NOTICE OF CHANGE

MIL-HDBK-1003/8A
NOTICE 1
30 AUGUST 1991

EXTERIOR DISTRIBUTION OF STEAM, HIGH TEMPERATURE WATER,
CHILLED WATER, NATURAL GAS, AND COMPRESSED AIR

Figure 24
Steel Carrier Piping Manhole Entry Detail
(no scale)

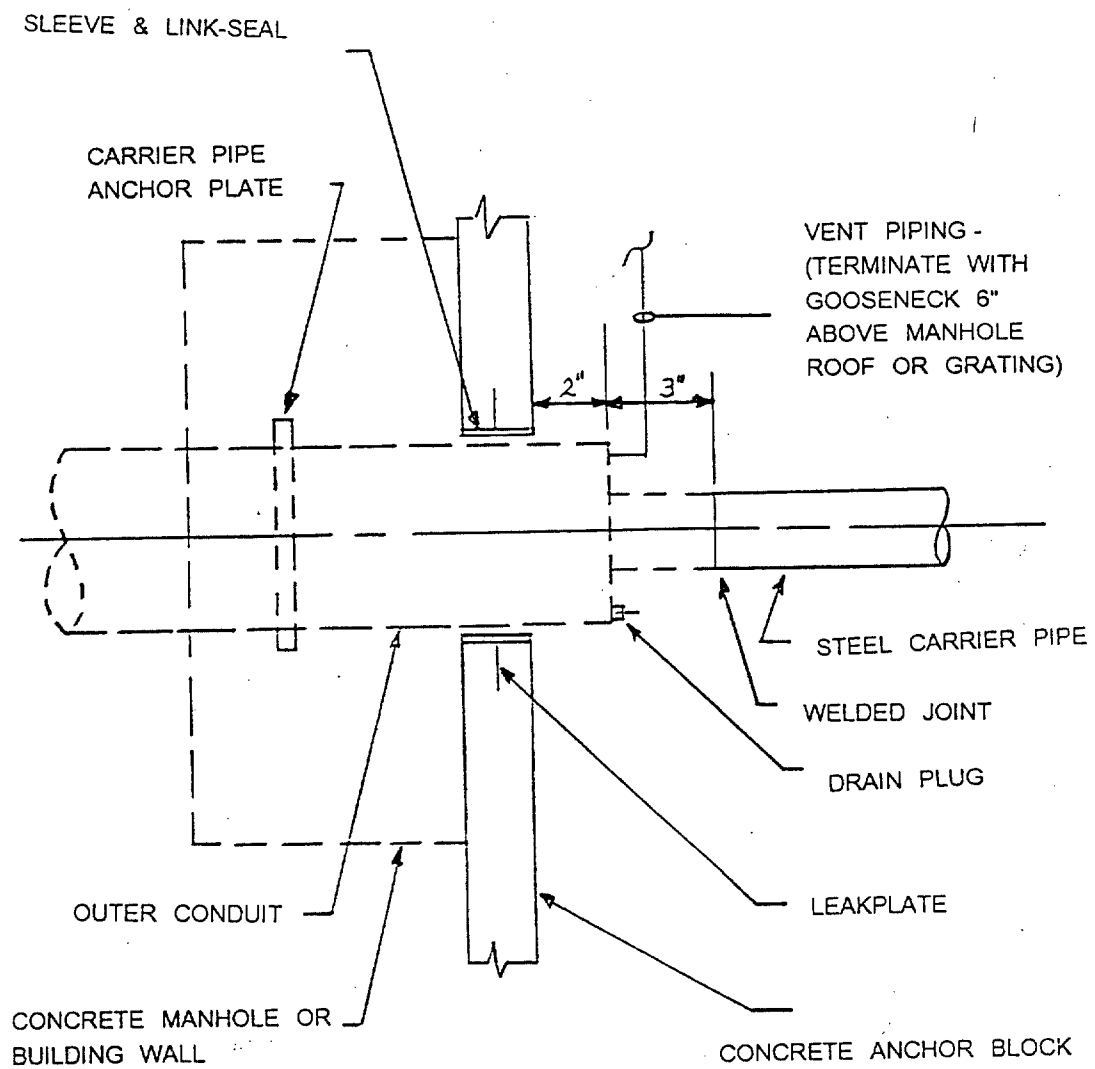
NEW PAGE	DATE	SUPERSEDED PAGE	DATE
63	30 August 1991	63	REPRINTED WITHOUT CHANGE
64	30 August 1991	64	30 August 1991

NOTE: THE CONTRACTOR SHALL DESIGN ITEMS INDICATED BY DASHED LINES.
